Draft Regulations

Cap-and-trade system for greenhouse gas emission allowances — Amendment

Regulation to amend the Regulation respecting a cap-and-trade system for greenhouse gas emission allowances

"Figure 3.1. Flowchart for the reduction project process

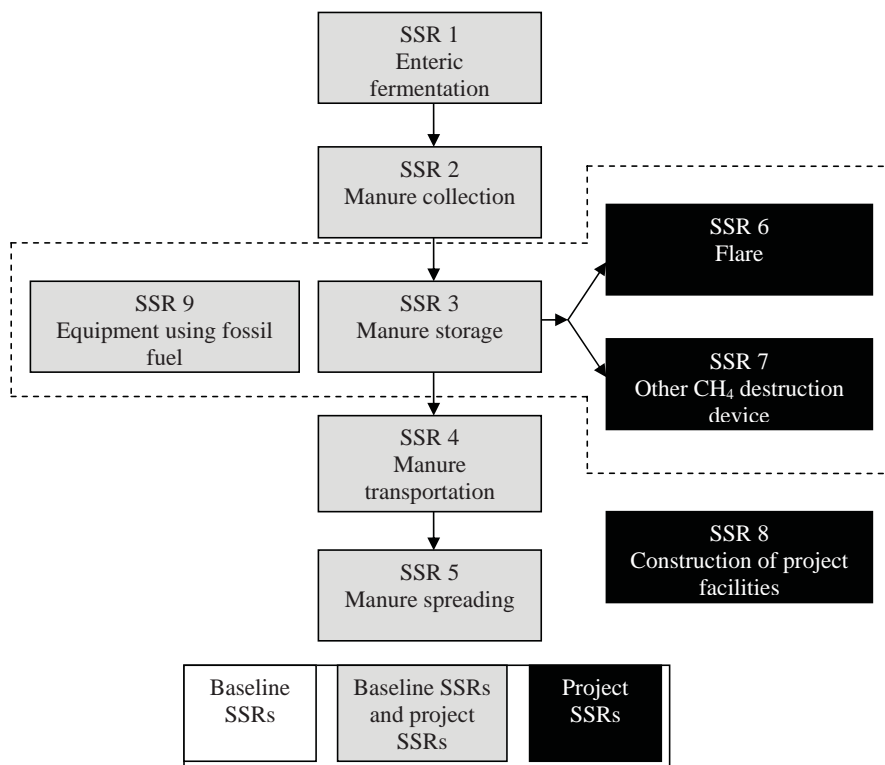
(d) by replacing Figure 3.1 in subdivision 3 of Part I by the following:

"Figure 5.1. Flowchart for the reduction project process

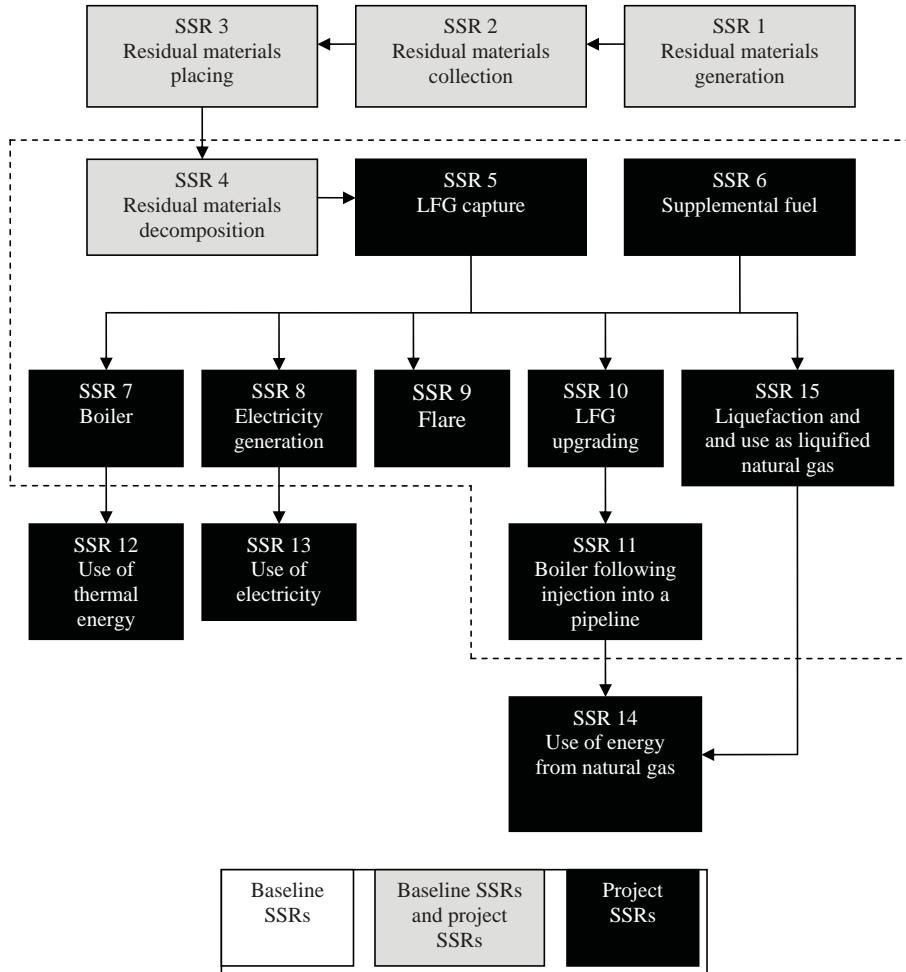
5. Reduction project SSRs";
 - (g) by replacing Figure 5.1 of subdivision 5 of Part I by the following:

Figure 4.1. Flowchart for the reduction project process

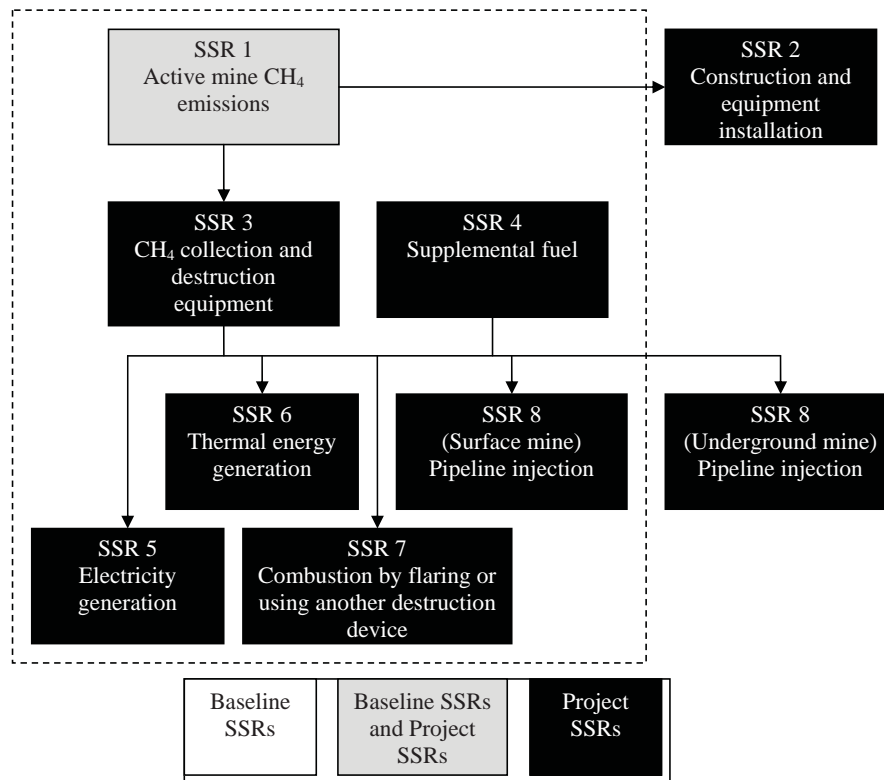
The reduction project process flowchart in Figure 4.1 and the table in Figure 4.2 show all the SSRs that must be taken into account by the promoter when calculating the GHG emission reductions attributable to the project.

All the SSRs within the dotted line must be counted for the purposes of this protocol.

Figure 4.1. Flowchart for the reduction project process

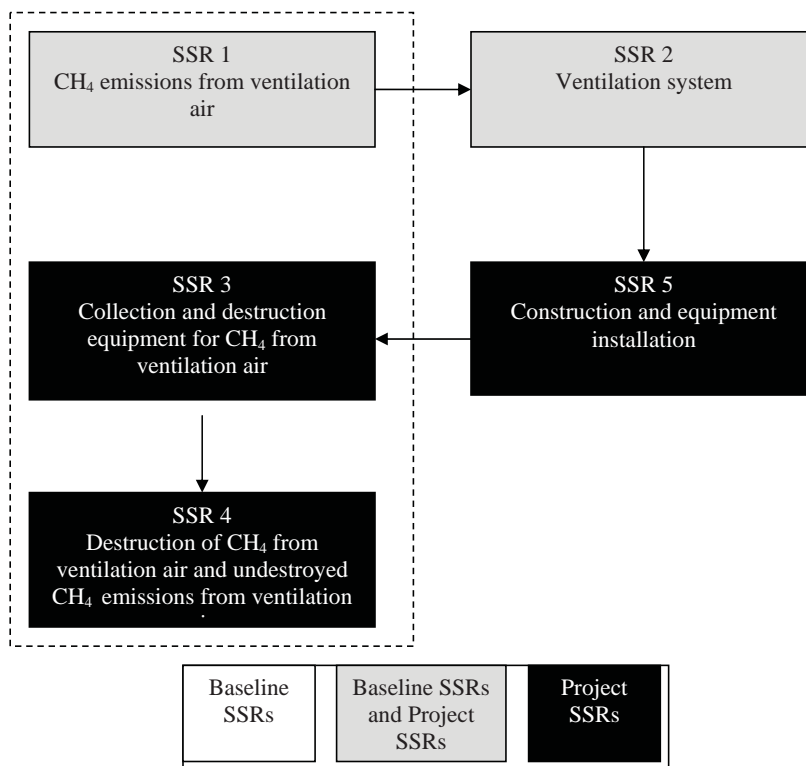
The reduction project process flowchart in Figure 4.1 and the table in Figure 4.2 show all the SSRs that must be taken into account by the promoter when calculating the GHG emission reductions attributable to the project.

All the SSRs within the dotted line must be counted for the purposes of this protocol.
